Access Compliance Report
Public Rights-of-Way
(Pedestrian Signals)

ADA ID: 2B19CED33981 **Signal Type:** One Push Button-APS **Overall Compliance:** No **Severity Score:** BTN 1: N/A BTN 2: N/A No BTN: N/A

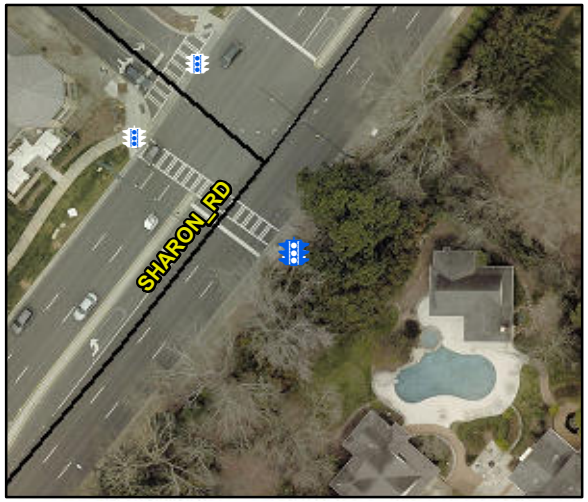
PROW/ADA: TMUTCD 4e.08, R404.2, R404.7.3, R209.1, MUTCD 4e.10

Possible Solutions: Replace Signal Push Button With APS Button on New Post. Remove & Relocate Sign.
